## Corvus H89-Z37 re-work:

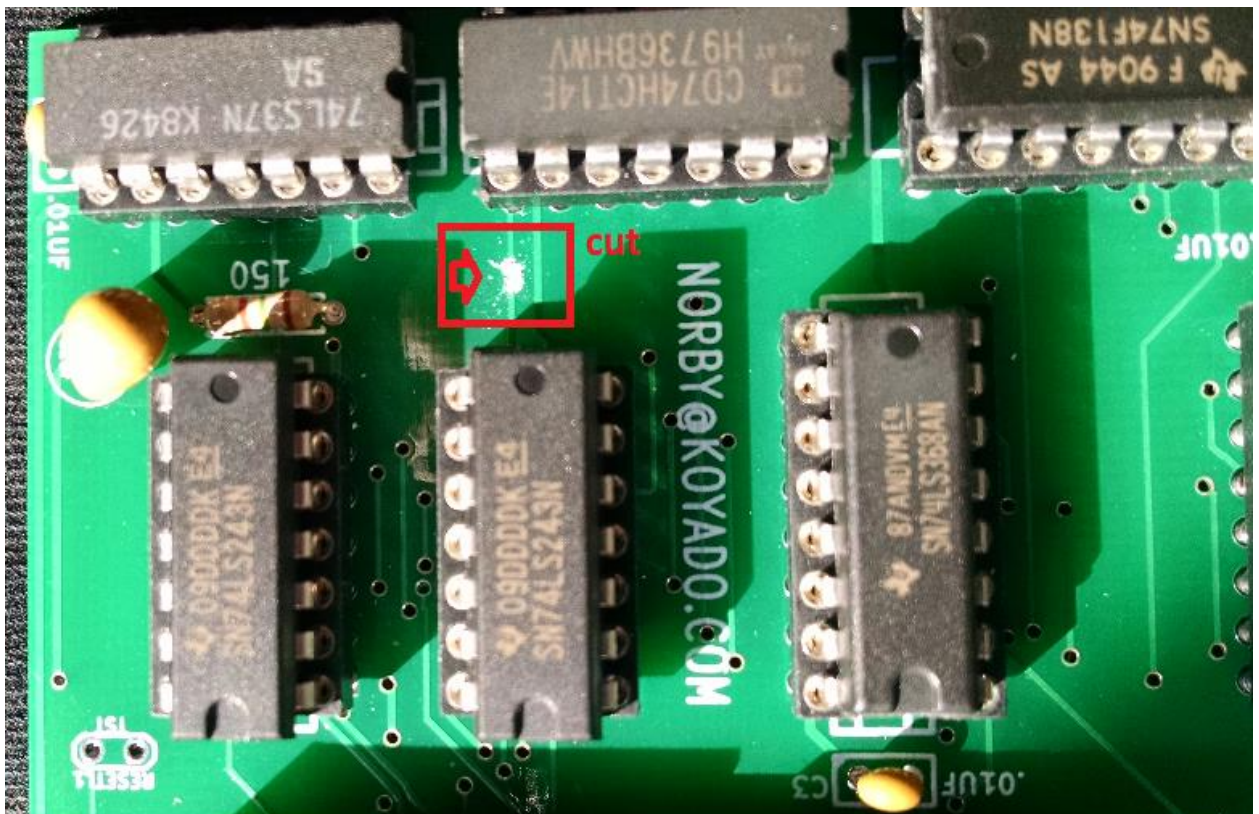
Issue: Corvus interface write signal fails to latch data on the Corvus data bus at proper time.

Solution: Use the available gates in U2 - 74LS14 pins to add more delay to the write signal.

1. Cut trace on side 1 as shown

2. Solder wire from pin 8 to pin 13 of U2.
3. Solder wire from pin 12 to pin 11 of U2.
4. Solder wire from pin 10 of U2 to pin 1 of U3.
5. See picture below as a reference.
